SUNDRY NOTICES AND REPORTS ON WELLS
Do not use this form for proposals to drill or to re-enter an abandoned well. Use Form 3160-3 (APD) for such proposals.

MADERA 12 FEDERAL SWD #1

Proposed Plug & Abandonment

**Permanent Abandonment of Federal Wells
Conditions of Approval (LPC Habitat)**

CURRENT WELLBORE

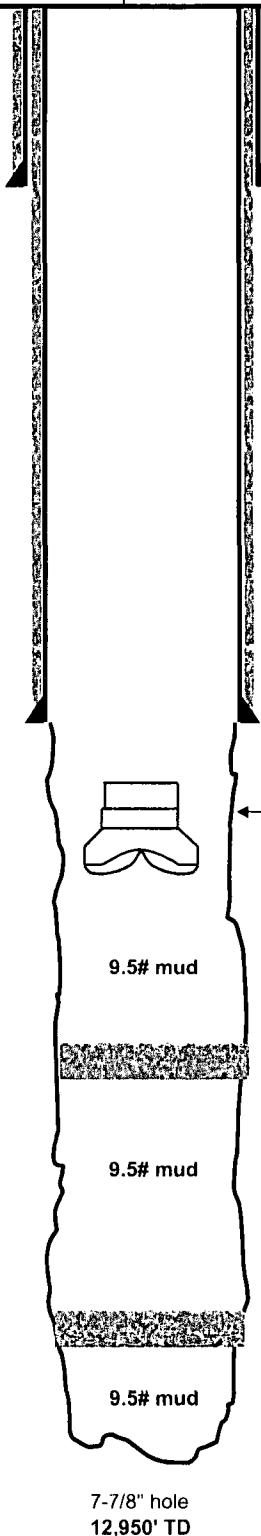
1. MIRU on P&A wellbore to clean out & convert to SWD. (Order SWD-1358)
2. Drilled out cement plugs. Cleaned out wellbore to 5780'. Stuck & left bha in hole from 5740' to 5780'. Unable to retrieve.
3. Devon proposes to abandon SWD conversion and plug and abandon wellbore.

1. Drill bit BHA Fish left in hole from 5740' to 5780' (X-Over, D/C, Bit Sub, & bit)
2. Tagged fill @ 5600' & washed down to 5699'. Proposed to plug & abandon-(8/12/14)

(Circulate 9# mud between cement plugs)

Below ground level dry hole marker required.
